Washington Village
Norwalk, Connecticut
FMC/FME 2014-01124

Response to CTDEEP Comments

July 24, 2014

Re: **Washington Village, Norwalk
Clarification of CTDEEP Comments**

MARK	DATE	DESCRIPTION
5	07-24-2014	REVISED PER CTDEEP COMMENTS
4	5-15-2014	REVISED PER CTDEEP COMMENTS
3	06-13-2014	75% CD SET
2	11-18-2013	40% CHFA CD SET
1	08-06-2013	PRICING SET

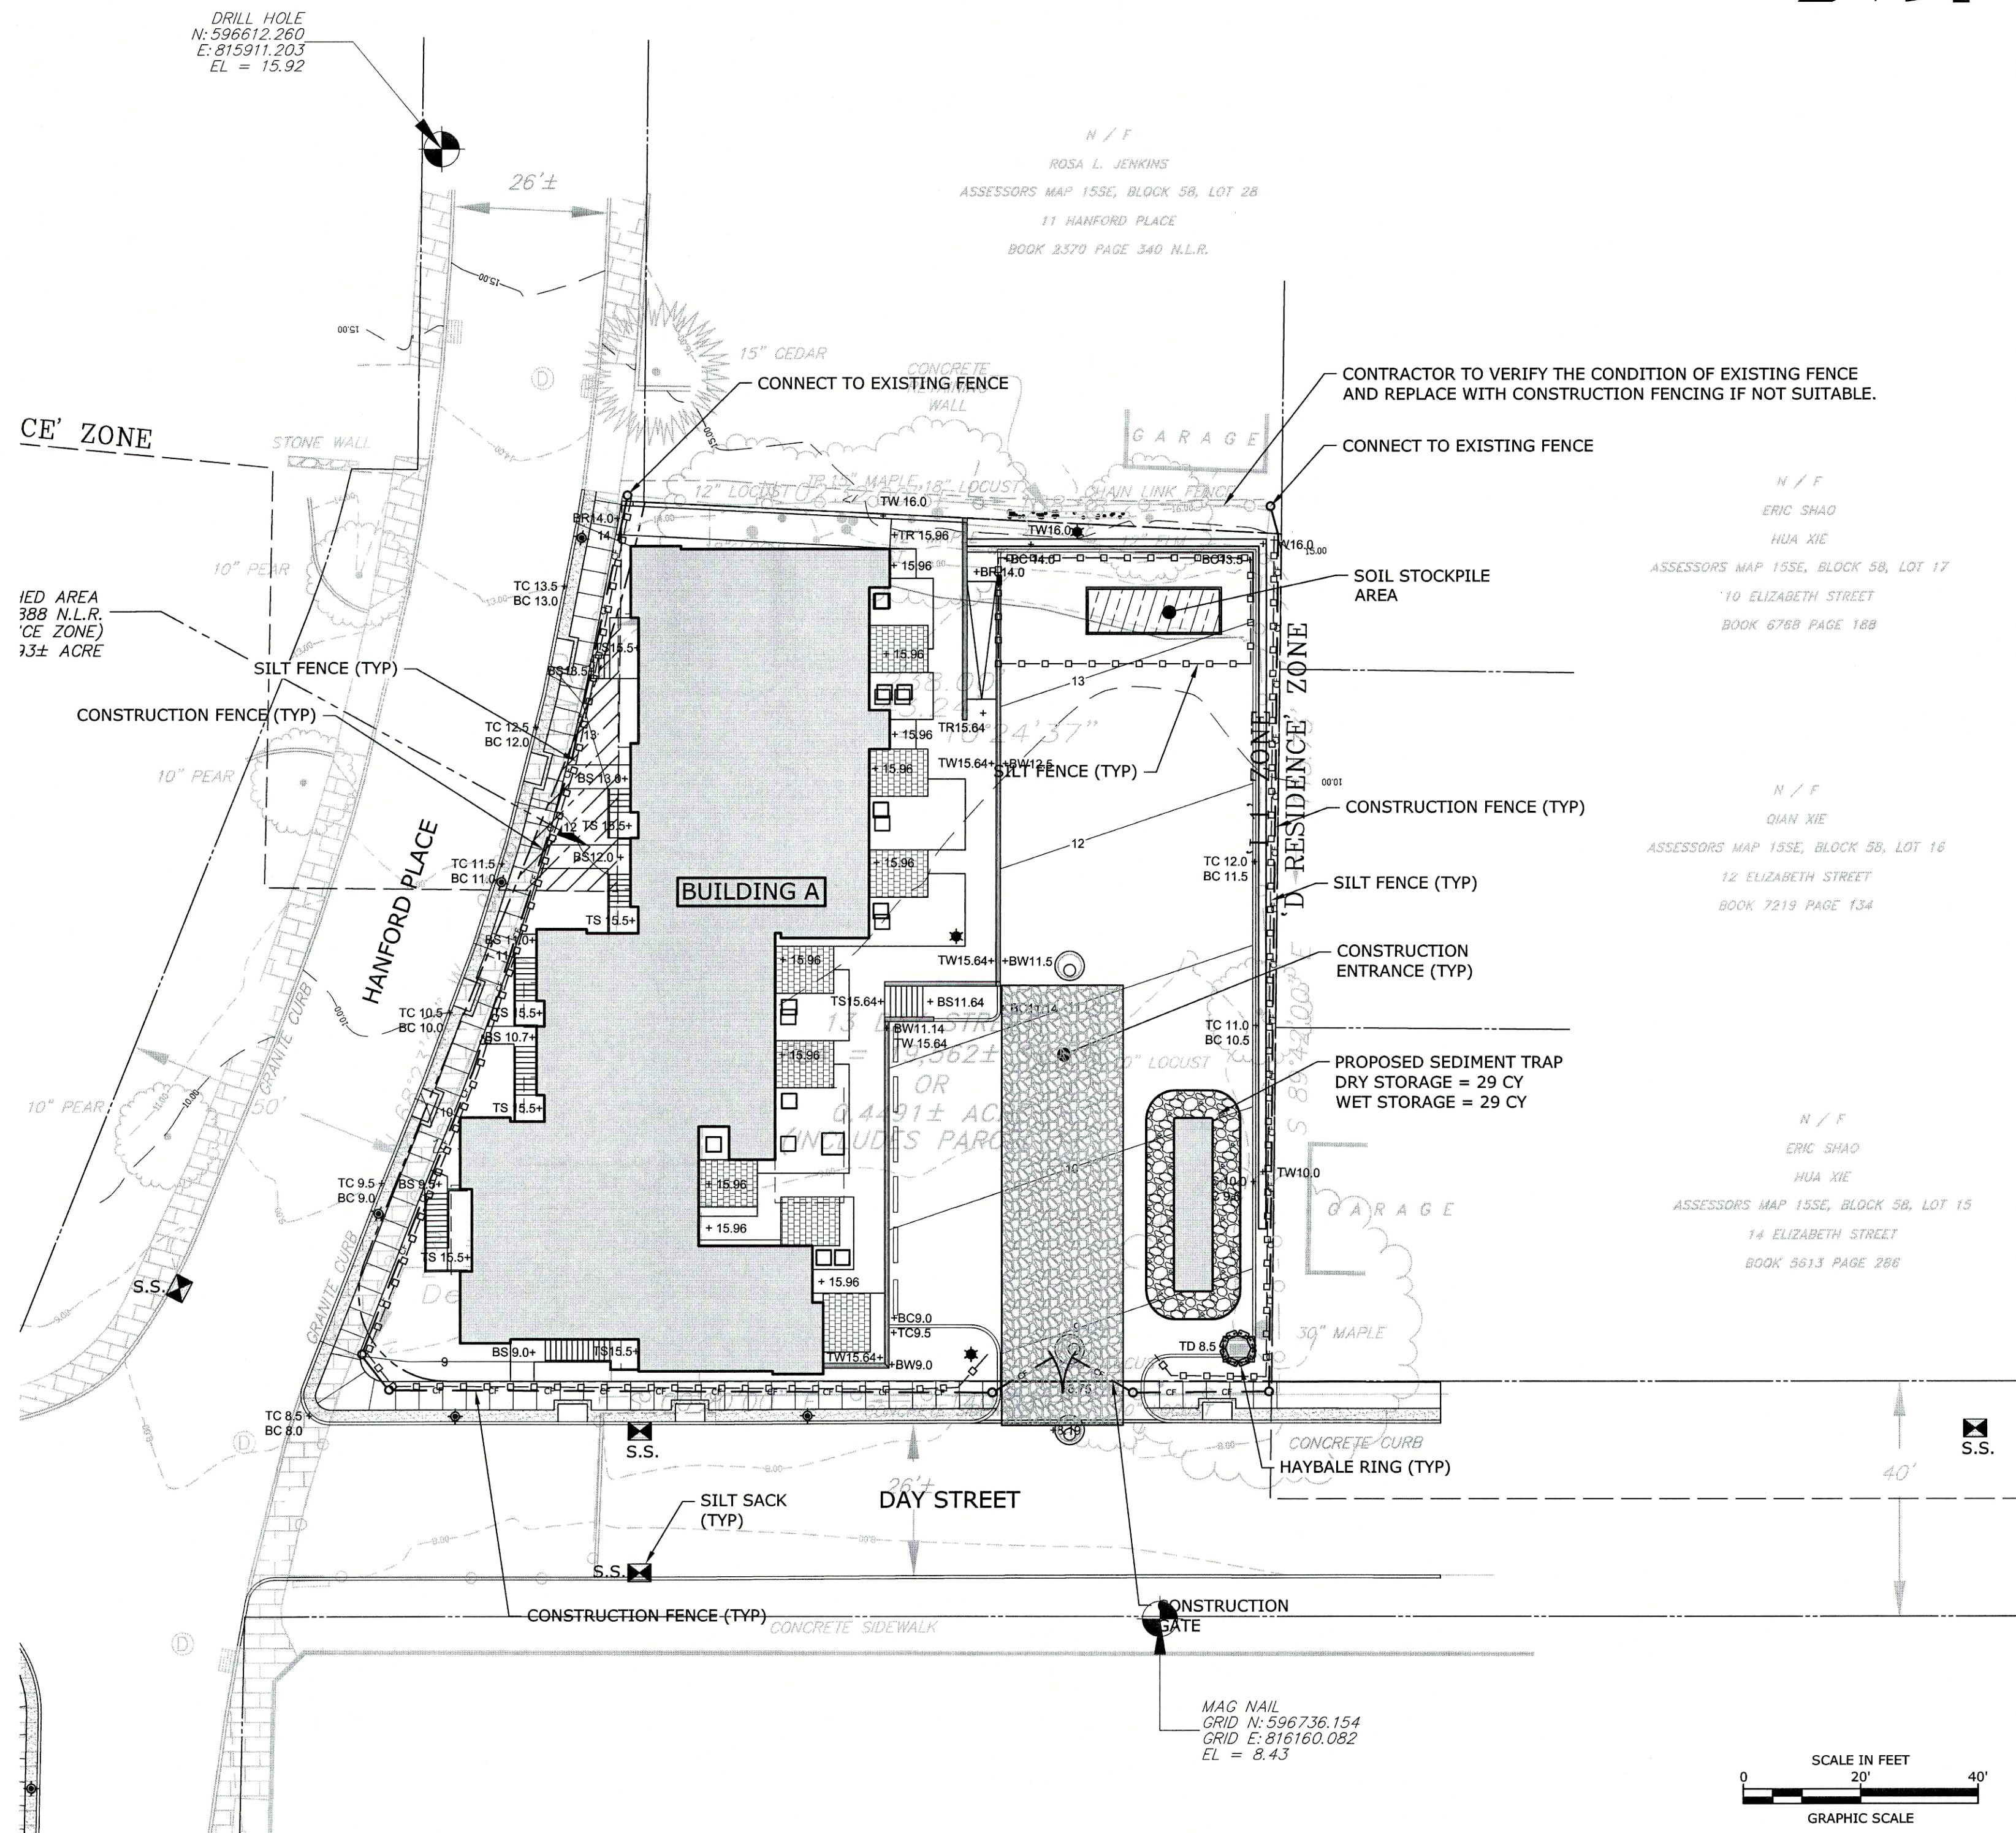
- **Attachment A (revised to correct 0.2% chance flood elevation)**
 - **Attachment H2, Section I, Question 3c (revised to correct 0.2% chance flood elevation)**
 - **Attachment H2, Section III (for \$ 3,000,000 Raymond/Day Grant)**
 - **Attachment H2, Section III (for \$ 4,500,000 Critical Community Improvements Implementation Grant)**
 - **Attachment H2, Section III (for \$ 400,000 CDBG Entitlement for Ryan Park)**
3. The Erosion and Sedimentation Control Plans note #28 must include the 500 year elevation of 15 feet NAVD88.

Note 27 (Building A) and Note 28 (Building B and Buildings C-D-E) have been revised to include the 0.2 percent chance floodplain elevation. The updated sediment and erosion control drawings appear in Appendix F.

27. HAZARDOUS MATERIALS INCLUDING, BUT NOT LIMITED TO, FUELS, MAINTENANCE FLUIDS, AND OTHER MATERIALS MUST BE STORED ABOVE THE 500 YEAR FLOODPLAIN AT THE END OF THE DAY. 500 YEAR FLOOD ELEVATION IS 15.0 NAVD88.
